Access Compliance Report

Public Rights-of-Way

Intersection ID: 15138	Main Street: FENTON_PL	Cross Street: HEMPSTEAD_PL	Location: SW
ADA ID: 004F219172E1	Ramp Type: PerpDiag	Initial Pass/Fail: Fail	Overall Compliance: No
		Severity Score: 12.5

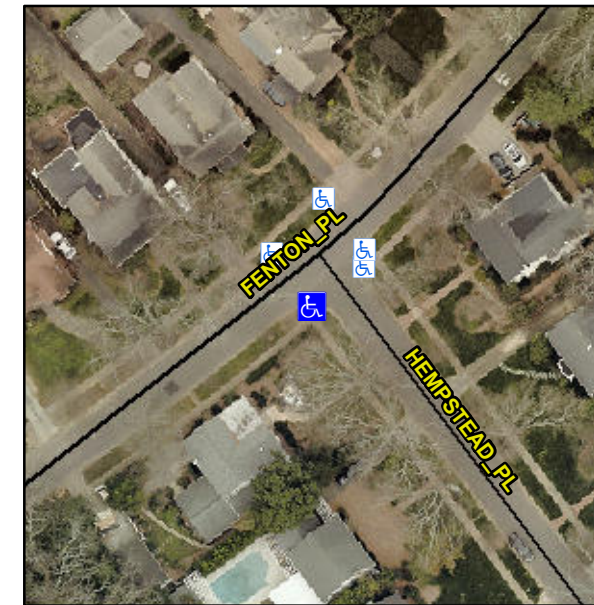
Compliance	Description	Data	Compliance	Description	Data
N/A	Ramp Length (in)	109.0	No	Ramp Slope (%)	8.5
Yes	Ramp Width (in)	74.0	Yes	Ramp XSlope (%)	1.4
N/A	Flare Type LT	N/A	N/A	Flare Type RT	N/A
N/A	Flare Slope LT (%)	N/A	N/A	Flare Slope RT (%)	N/A
N/A	Flare Traversable LT?	N/A	N/A	Flare Traversable RT?	N/A
N/A	Landing Length (in)	N/A	N/A	DWS Provided?	N/A
N/A	Landing Width (in)	N/A	N/A	DWS Contrast?	N/A
N/A	Landing Slope (%)	N/A	N/A	DWS Length (in)	N/A
N/A	Landing X Slope (%)	N/A	N/A	DWS Full Width?	N/A
N/A	Landing Curb? (Y/N)	N/A	N/A	DWS Offset (in)	N/A
N/A	Shared Landing?	N/A			
N/A	Gutter Ponding?	N/A	N/A	Gutter Slope (%)	N/A
N/A	Gutter Lip Ht (in)	N/A	N/A	Gutter X Slope (%)	N/A
N/A	Painted X Walk1?	No	N/A	Painted X Walk2?	No
	X Walk 1 Direction	To NE		X Walk 2 Direction	To NW
N/A	X Walk 1 Width (in)	N/A	N/A	X Walk 2 Width (in)	N/A
	X Walk 1 Slope (%)	1.6		X Walk 2 Slope (%)	1.3
	X Walk 1 X Slope (%)	4.3		X Walk 2 X Slope (%)	0.0

Remove & Replace Curb Ramp With Two New Directional Ramps or Equivalent.
